# Access Compliance Report

## Public Rights-of-Way

### (Curb Ramps)

Intersection ID: 29394	Main Street: AMBERGLADES_LN	Cross Street: GARDENIA_ST	Location: SE
ADA ID: CE77F39A43D3	Ramp Type: PerpDiag	Initial Pass/Fail: Fail	Overall Compliance: No
Severity Score: 33.75			
Codes/Mitigation Info/Possible Solution		Field Measurements/Component Compliance

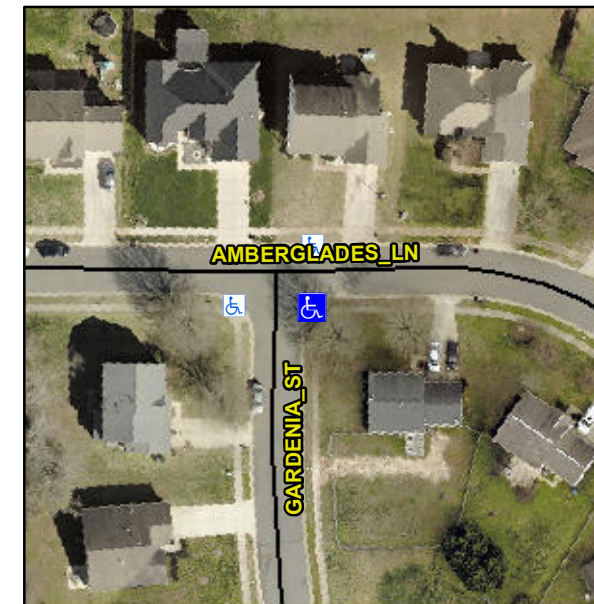
**Not Found, R304.5.1, R304.5.3**

Compliance	Description	Data	Compliance	Description	Data
N/A	Ramp Length (in)	48.5	Yes	Ramp Slope (%)	5.1
No	Ramp Width (in)	47.0	No	Ramp XSlope (%)	11.2
N/A	Flare Type LT	N/A	N/A	Flare Type RT	N/A
N/A	Flare Slope LT (%)	N/A	N/A	Flare Slope RT (%)	N/A
N/A	Flare Traversable LT?	N/A	N/A	Flare Traversable RT?	N/A
N/A	Landing Length (in)	N/A	N/A	DWS Provided?	N/A
N/A	Landing Width (in)	N/A	N/A	DWS Contrast?	N/A
N/A	Landing Slope (%)	N/A	N/A	DWS Length (in)	N/A
N/A	Landing X Slope (%)	N/A	N/A	DWS Full Width?	N/A
N/A	Landing Curb? (Y/N)	N/A	N/A	DWS Offset (in)	N/A
N/A	Shared Landing?	N/A			
N/A	Gutter Ponding?	N/A	N/A	Gutter Slope (%)	N/A
N/A	Gutter Lip Ht (in)	0.5	N/A	Gutter X Slope (%)	N/A
N/A	Painted X Walk1?	No	N/A	Painted X Walk2?	No
	X Walk 1 Direction	To N		X Walk 2 Direction	To W
N/A	X Walk 1 Width (in)	N/A	N/A	X Walk 2 Width (in)	N/A
	X Walk 1 Slope (%)	4.1		X Walk 2 Slope (%)	2.3
	X Walk 1 X Slope (%)	6.4		X Walk 2 X Slope (%)	7.4

N/A	Ramp inside XWalk1?	N/A	N/A	Ramp inside XWalk2?	N/A
	Road Slope (%)	8.4	N/A	Clear Space?	N/A
	Road X Slope (%)	1.4	N/A	Clear Space to XWalk (in)	N/A
N/A	Any Obstructions?	N/A	N/A	Storm Grate/Utility Hazard?	N/A
	Obstruction Type			Storm Grate/Utility Type	
		N/A			N/A
		Yes		Surface Condition? (G/P)	Good

**Remove & Replace Curb Ramp With Two New Directional Ramps or Equivalent.**
